5745 PINE FLAT ROAD

**RE: Sonoma County PMRD Plan Check #EI-147608**  
**5745 Pine Flat Road, Timothy Carlson Driveway**

**RE: Sonoma County PMRD Plan Check #B-147608  
5745 Pine Flat Road Private Driveway Plans**

**Re: Sonoma County PRMD Plan Check #B-147608  
5745 Pine Flat Road Private Driveway Plans**

**CULVERT DESIGN - STA 2+00**

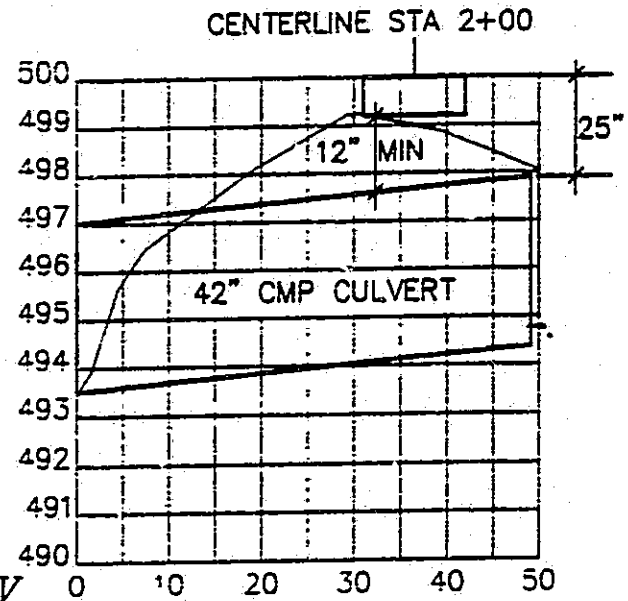
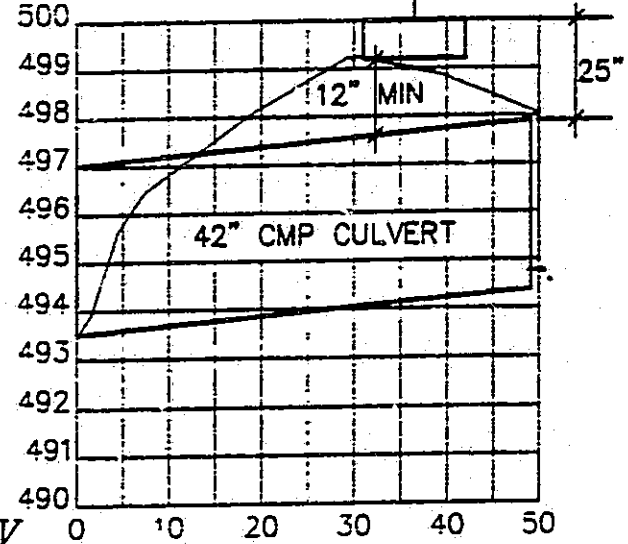
3. Indicate inverts and slopes for all proposed drainage piping. It appears that the grades given for the 42" culvert at station 2+00 do not match the contour elevation change in that location.

This letter is written in response to your fax of October 1, 1998 following a meeting with yourself and Lola Coretti of the PRMD. The 42 inch CMP culvert we are proposing to install at station 2+60 created concerns because the drainage was then flowing to an existing 24 inch CMP under Pine Flat Road.

3. Culvert inverts are indicated on plan. Slope is indicated on culvert detail as a minimum of 2 percent.

6. At Sta. 2+00: added note to re-align existing drainage's to large CMP inlet. Fill will be required in this area. At Sta. 3+50 (uphill) the small drainage shown does not continue as concentrated flow all the way to the existing barn (per observations last wet-weather season). The roadside ditch is sized to pick up the estimated flow from this

According to Jesse Foster (drainage engineer for Department of Public Works), the existing 24 inch culvert is due to be replaced with a 48 inch diameter CMP culvert as a result of storm damage. Jesse is confident that the culvert is adequately sized for the existing drainage and the proposed driveway. The culvert is scheduled to be replaced in late October or early November of this year. The culvert is identified as M07805 (Storm Damage Site) both on the DPW plans and painted on the pavement near the culvert to be replaced. Please contact Jesse Foster if this information needs to be verified.

September 23, 1998  
Timothy Carlson Drainage Sketch Map  
5745 Pine Flat Rd., Healdsburg  
Job# 97-106

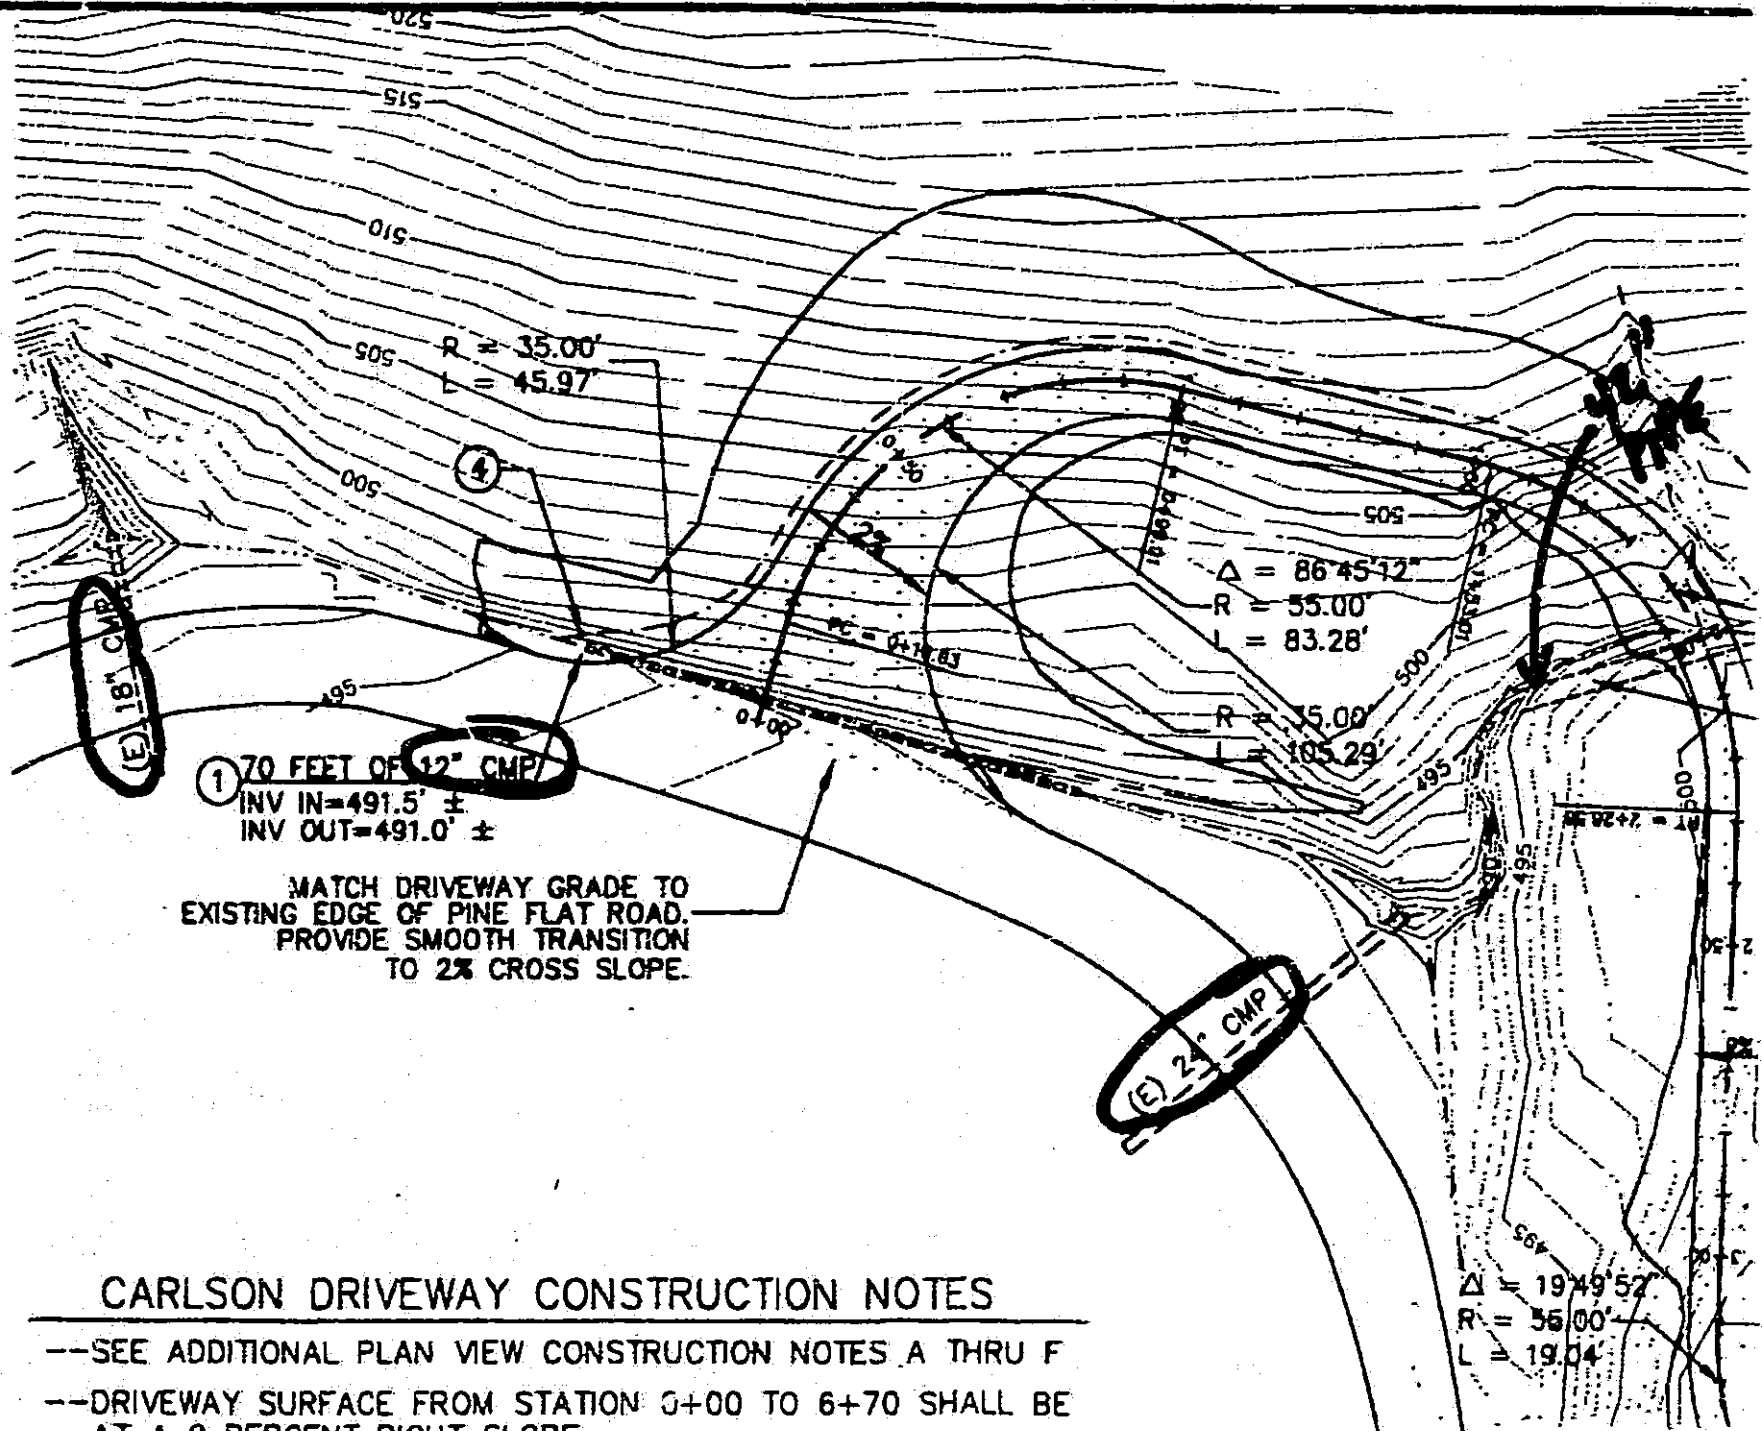
1. Check inlet control conditions for all culverts crossing the proposed driveway.
2. Indicate the location of the proposed driveway on the hydrology map.

1. The topographic map has been revised to show an existing 18" cnp culvert immediately up the road from the proposed 12" culvert at Sta 0+10. Field observations indicate that a 12" culvert will be oversized. The hydrology sketch map has been revised to show a new Tributary 3, the tributary area has been field checked due to the lack of resolution of the county lot line topo maps. Tributary 3 is assumed to have the same characteristics as Tributary 2 and approximately half the estimated flowrate. No revisions were made to the SCWA Rational Method Hydrology output. Inlet control conditions are included in the hydrology calculations for all culverts.

2. Hydrology map has been revised to indicate the driveway location.

Drainage calculations for Tributary 3 are included (unintentionally left off the last drainage calc's), and acreage is shown for each tributary area in the enclosed map.
